## Cardinia Planning Scheme - Amendment C238

### Am C238 Submissions

Sixteen submissions have been received in relation to Amendment C238. The submissions have been consolidated into this one document.

Figure 14. Location of Proposed DCP Items (Development Contributions Plan (Draft) June 2020, Urban Enterprise & Cardinia Shire Council)

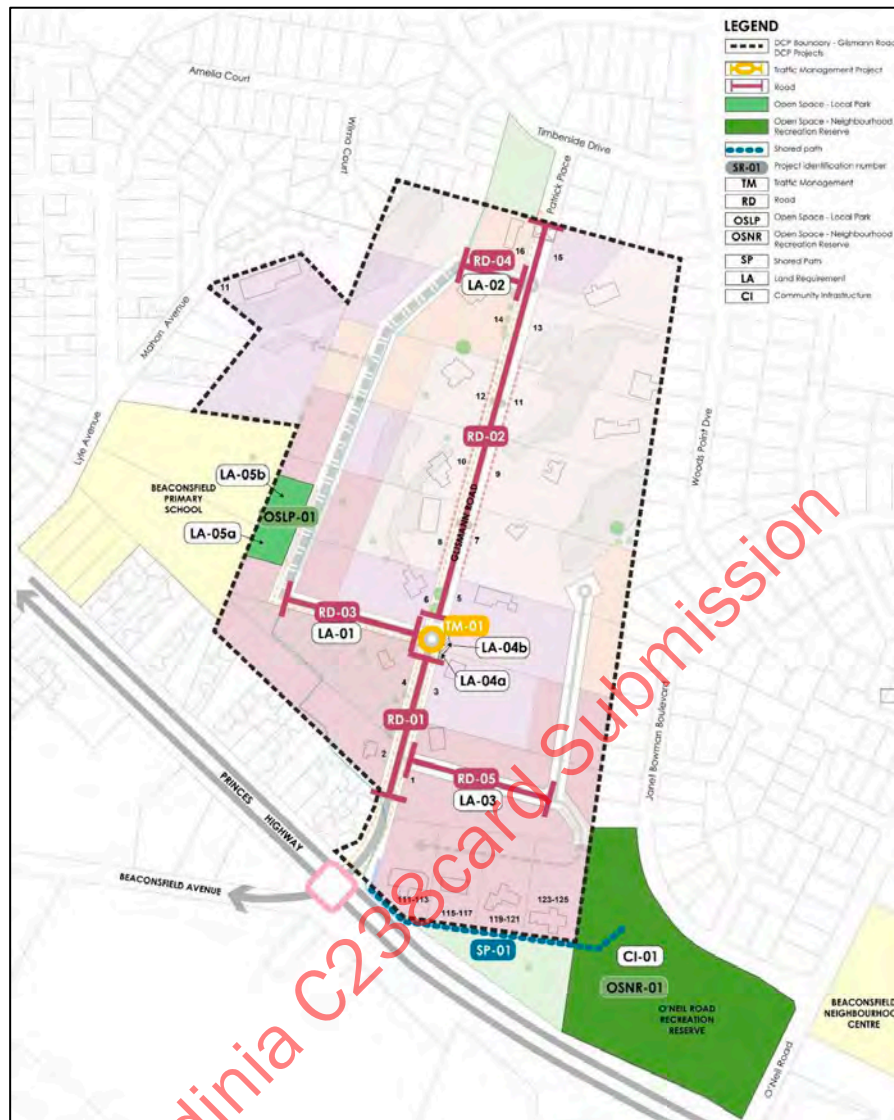
The important outcome of the above assessment is that although portrayed as only a minor road connection on the proposed Development Plan, it would not be minor at all. It would in fact require a massive amount of earthworks and take up considerable developable area, at a great cost to the land owners. The cost would be borne by the landowners of the subject site [REDACTED] as this infrastructure item has been excluded from the proposed DCP. A copy of the DCP Item Plan is included at Figure 14, overleaf.
